Access Compliance Report

Public Rights-of-Way

(Curb Ramps)

Intersection ID: N/A	Main Street: ROUNDING_RUN_LN	Cross Street: RISING_MEADOW_RD	Location: NE
ADA ID: C903A815EFF9	Ramp Type: PerpDiag	Initial Pass/Fail: Fail	Overall Compliance: No
		Severity Score: 12.5

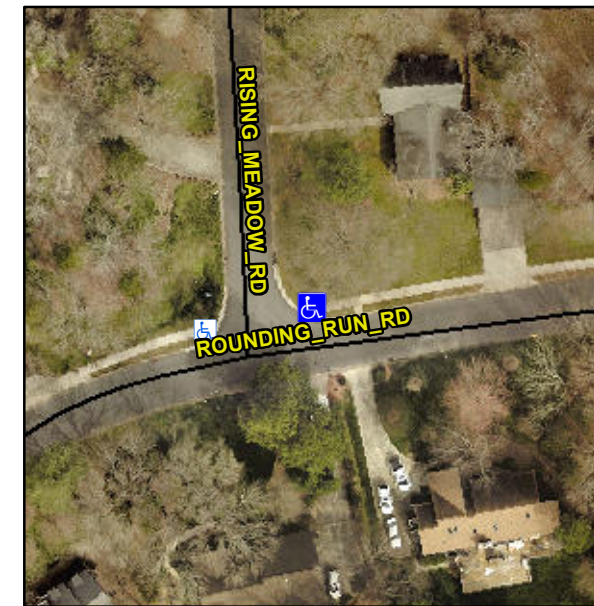
Not Found, R304.5.3

Remove & Replace Curb Ramp With Two New Directional Ramps or Equivalent.
